RBG-47374

SUBJECT: Response to Request for Additional Information (RAI) for the Overall Integrated Plan (OIP) in Response to the Commission Order Modifying Licenses with Regard to Requirements for Reliable Spent Fuel Pool (SFP) Instrumentation River Bend Station – Unit 1  
Docket No. 50-458  
License No. NPF-47

**River Bend Station (RBS) Spent Fuel Pool (SFP) Order  
Request for Additional Information (RAI) Responses**

FIGURE 1 (SFP Elevation View with Levels Indicated)

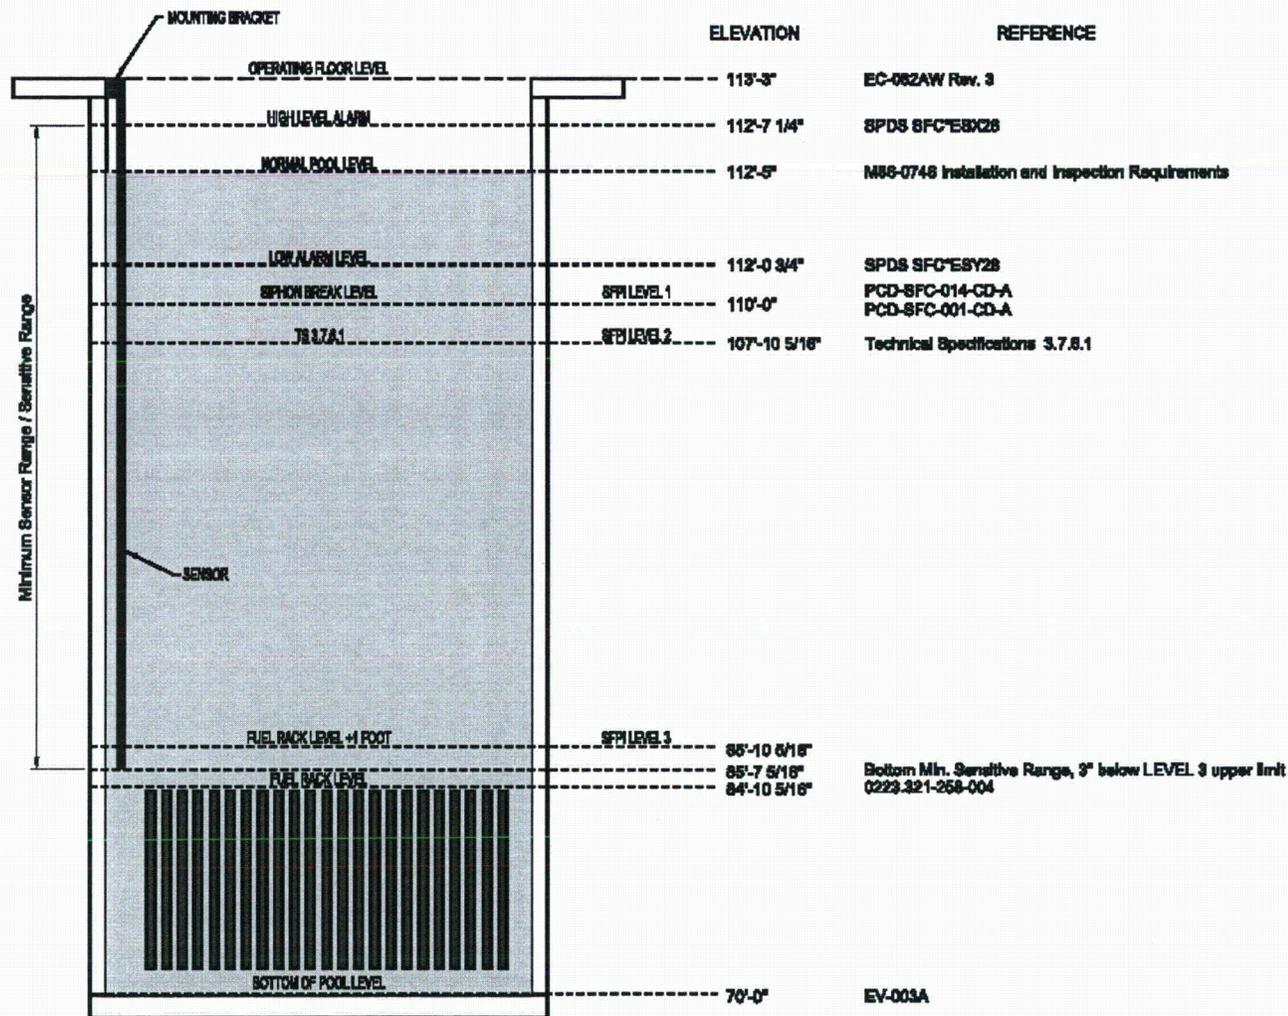
**RAI-1.a Please provide a clearly labeled sketch depicting the elevation view of the proposed typical mounting arrangement for the portions of instrument channel consisting of permanent measurement channel equipment (e.g., fixed level sensors and/or stilling wells, and mounting brackets). Please indicate on this sketch the datum values representing Level 1, Level 2, and Level 3 as well as the top of the fuel. Indicate on this sketch the portion of the level sensor measurement range that is sensitive to measurement of the fuel pool level, with respect to the Level 1, Level 2, and Level 3 datum points.**

**RAI-1.b The OIP states, in part, that "other hardware stored in the SFP will be evaluated to ensure that it does not adversely interact with the SFP instrument probes during a seismic event." Given the potential for varied dose rates from hardware stored in the SFP, please describe how Level 2 will be adjusted to other than the elevation provided above.**

The requested information is provided in Figure 1. The figures indicate Levels 1, 2, and 3 as well as the approximate location of the proposed mounting bracket incorporating the Seismic Category I attachment. The sensor is a perforated tubular coaxial waveguide that provides continuous level measurement axially and is sensitive over its entire length. These sketches apply to both the primary and backup channels.

The spent fuel pool (SFP) level lower instrument span or probe bottom extends down to at least three inches below the upper limit of the range of Level 3 to account for channel accuracy or instrument loop uncertainty. Therefore, the SFP level probe bottom/span extends down to at least elevation 85'-7 5/16" (see Figure 1). The SFP level upper instrument span, at a minimum, includes normal water level high alarm. Note that Level 3 is shown in accordance with Nuclear Energy Institute (NEI) 12-02 Revision 1 guidance relative to the top of the rack; the top of the fuel is not shown.

The River Bend Station spent fuel pool instrumentation utilizes permanently installed equipment and does not require the installation of any portable instrumentation. Level 2 is specified at the Technical Specification minimum limit (refer to Figure 1).

Figure 2

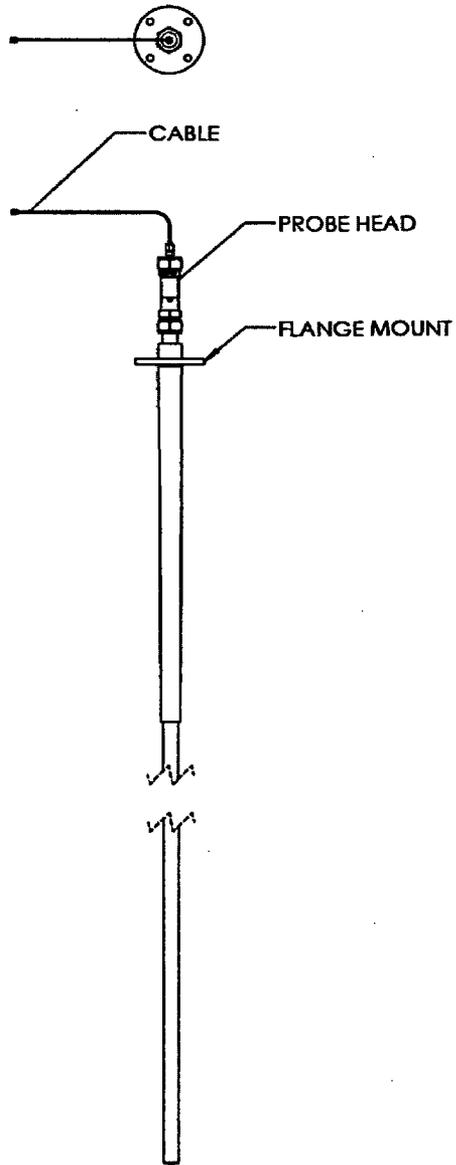
**RAI-3.b Please provide a description of the manner in which the level sensor (and stilling well, if appropriate) will be attached to the refueling floor and/or other support structures for each planned point of attachment of the probe assembly. Please indicate in a schematic the portions of the level sensor that will serve as points of attachment for mechanical/mounting or electrical connections.**

The proximal portion of the level probe is designed to be attached near its upper end (refer to vendor schematic Figure 2) to a Seismic Category I mounting bracket configured to suit the requirements of a particular SFP. The bracket may be bolted

and/or welded to the SFP deck and/or SFP liner/wall according to the requirements of the particular installation per Seismic Category I requirements.
